RESOURCE CONSERVATION AND RECOVERY ACT FACILITY INVESTIGATION REPORT
ADDENDUM AREA OF CONCERN 525 (AOC 525) ZONE E CNC CHARLESTON SC
11/18/2003
CH2M HILL

Area of Concern 525, Zone E

Re: Revision 1 pages for *RFI Report Addendum, AOC 525, Zone E, Revision 0* – Originally Submitted on July 23, 2002

**Response To Comments from Charles B. Watson — SCDHEC
for Draft Zone E RCRA Facility Investigation Report
Charleston Naval Complex**

Figure 2-2
 Monitoring Well Locations
 AOC 525, Zone E
 Charleston Naval Complex

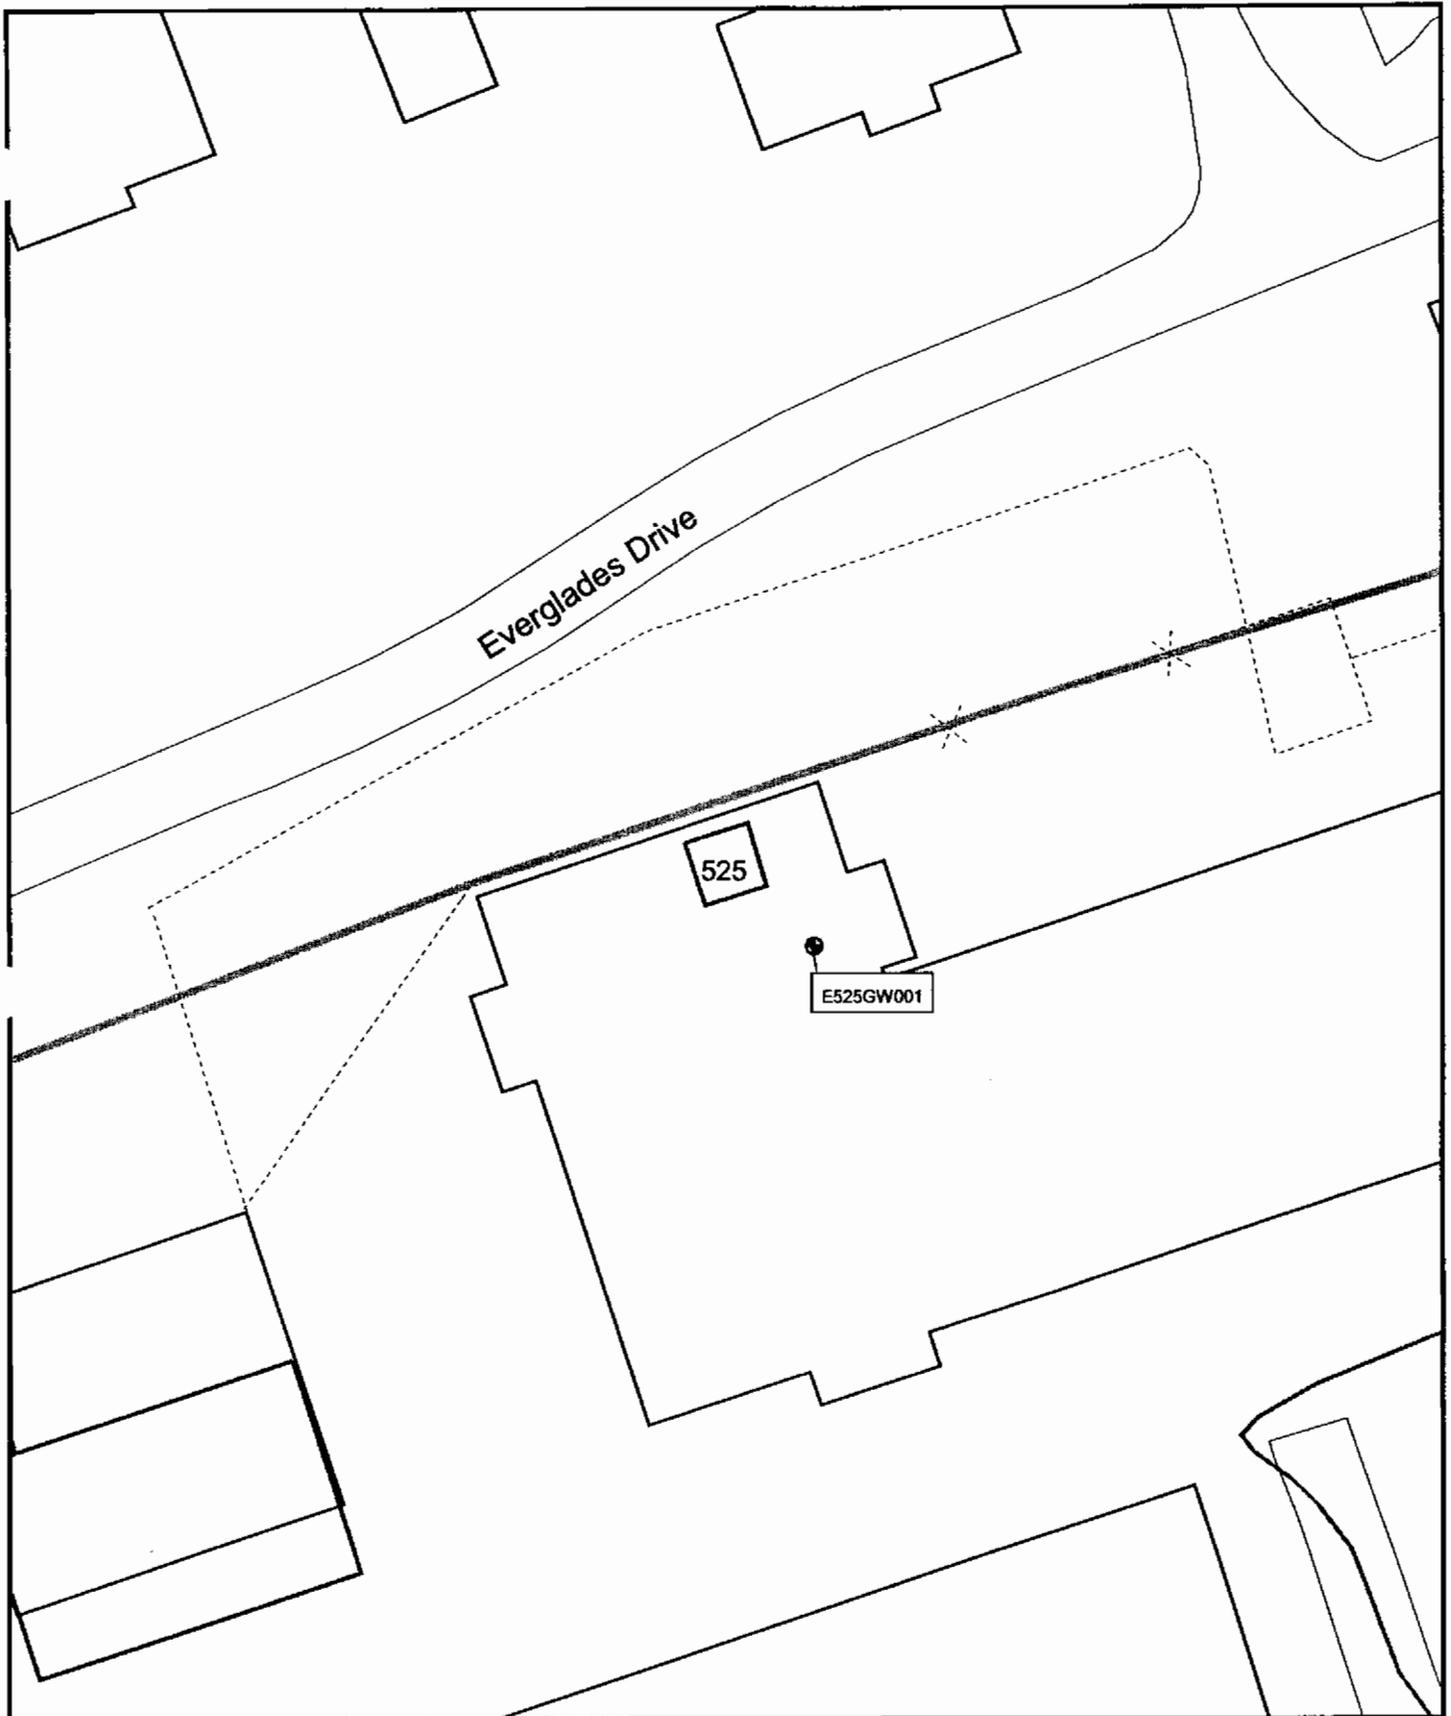
2. AOC 525 has only one shallow monitoring well, 525GW001, to assess groundwater at this site. The nearest shallow monitoring is approximately 175 feet to the south west of the AOC and is side gradient. The nearest upgradient monitoring well is >650 feet to the northwest. This results in the Navy defining the groundwater flow at this AOC with one monitoring well. Furthermore, the RFI Report Addendum has not fully addressed the waste management process of this AOC. Without understanding the site groundwater flow or the waste management process it is not possible to conclude that the single shallow monitoring well is adequate to assess the groundwater at this site. The Navy may need to install upgradient and downgradient monitoring wells. The Navy must demonstrate adequate groundwater assessment at this AOC.

The Zone E RFI work plan specified the level of groundwater sampling and investigation required for this site after careful review of site conditions, assessment of the potential for release and impacts to the environment, and evaluation of relevant operational data. The CNC BCT that developed and approved the Zone E RFI work plan considered a single well adequate to assess whether groundwater was impacted at the site. It was installed based on a thorough and appropriate review of site information and installed where the team believed it was most likely to detect impacts from site operations. Because of the time frame that the RFI work plan was developed (1994 to 1995), the CNC BCT members that developed the work plan were able to interview site personnel that had worked at the facility for many years and use information from these employees to refine the investigation work plan and best locate the sampling locations to detect potential contamination.
